**EnergyAustralia Public Lighting Operating Expenditure
Submission to AER for Re-Determination 2010-14**

Reassessment of Recommendations

22 March 2010

Figure 7.1 Public Lighting Opex per Network Customer

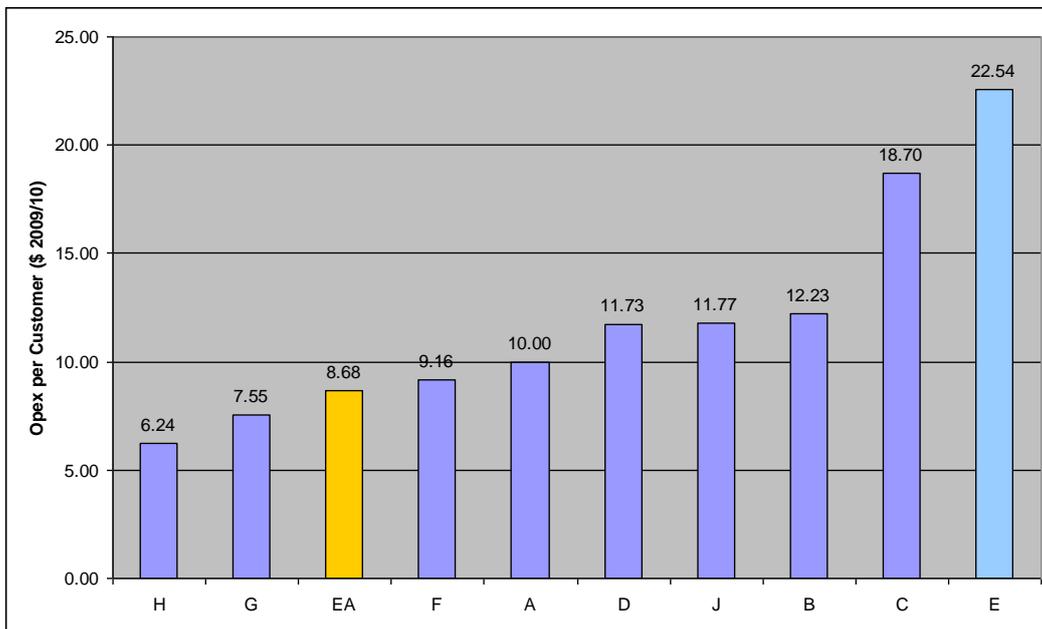
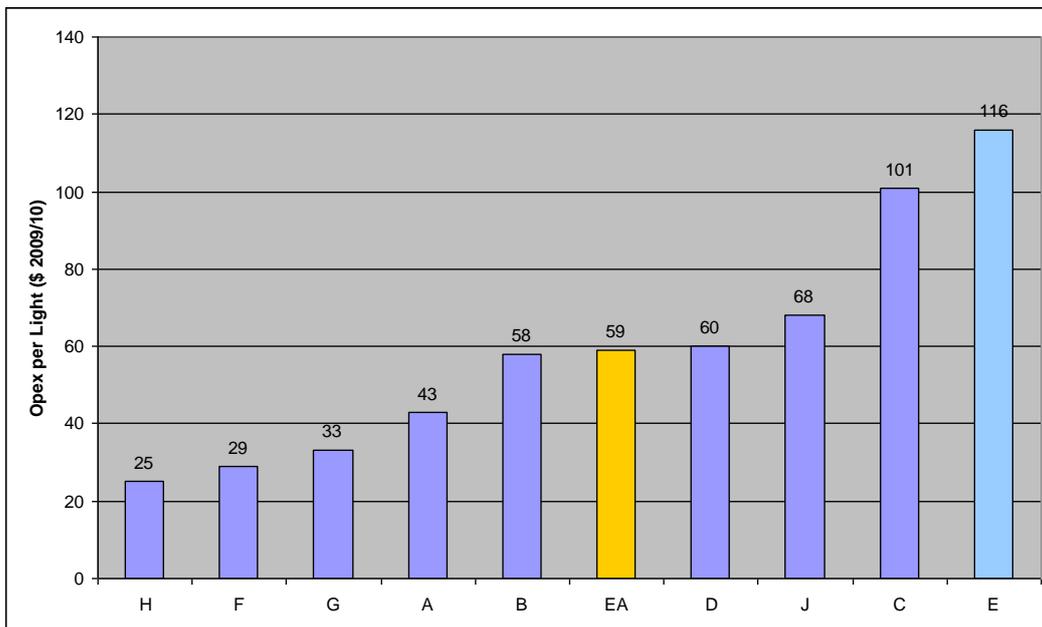
- The causal link between public lighting opex and customer numbers is weak and therefore performance measured in terms of cost per customer is of little value; and
- The inherent cost characteristics of wholly rural DNSPs are such that benchmarking predominantly CBD/urban DNSPs against them is invalid.

That being the case, EMS considers Figure 7.1 is of little benchmarking value and omits DNSPs C and E due to their being wholly rural. The remaining elements of PB's benchmarking that provide a reasonable comparison are as shown in Figure 7.3.
